ODCM Revisions

Salem ODCM

OFFSITE DOSE CALCULATION MANUAL

SALEM GENERATING STATION

FIGURE E-1: ONSITE SAMPLING LOCATIONS

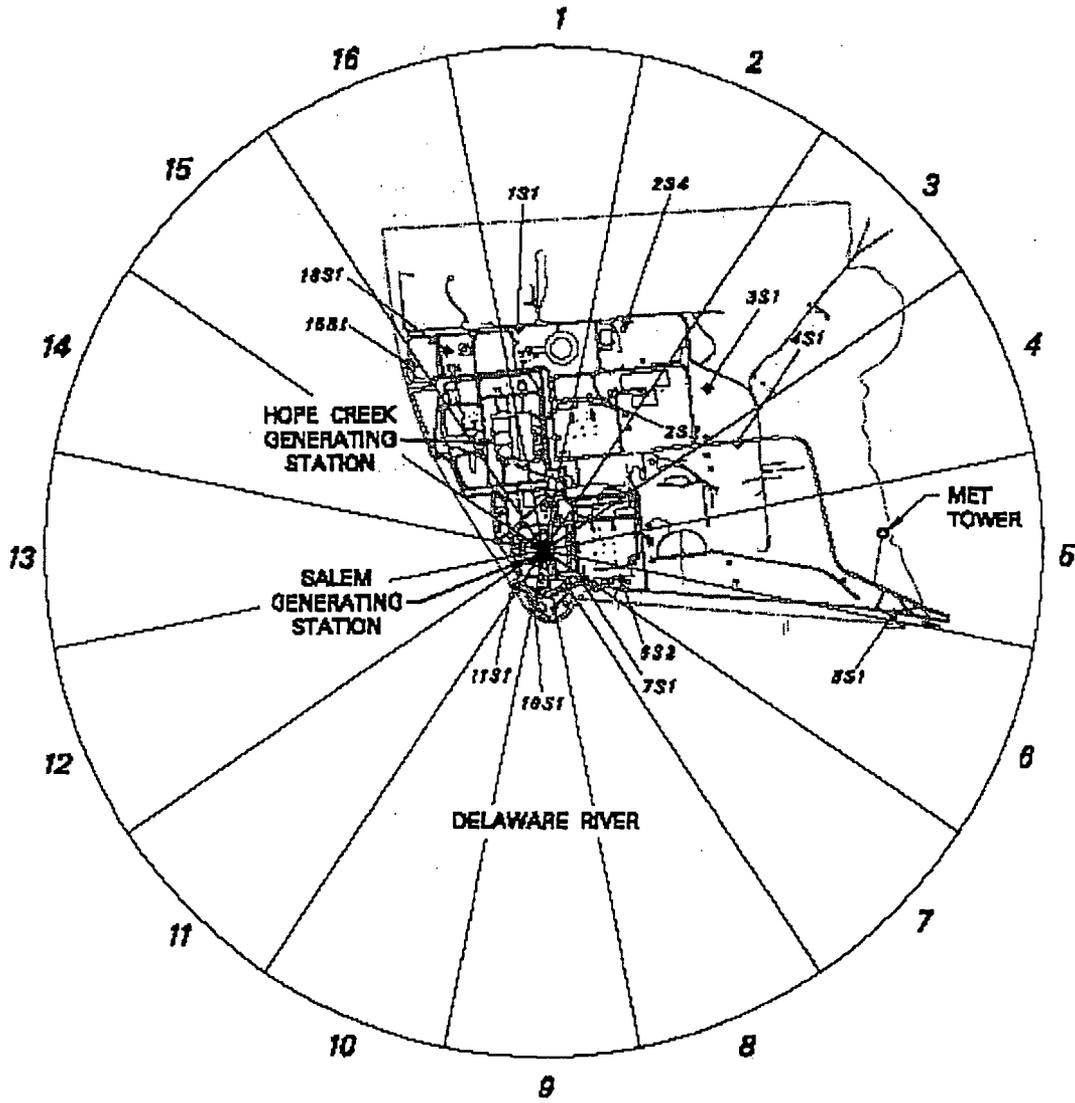
3. Updated Figures E-1 On-site Sampling Locations and E-2 Off-site Sampling Locations to update the new sampling locations.

Justification: The maps were updated to be consistent with the REMP station locations listed in Table E-1.
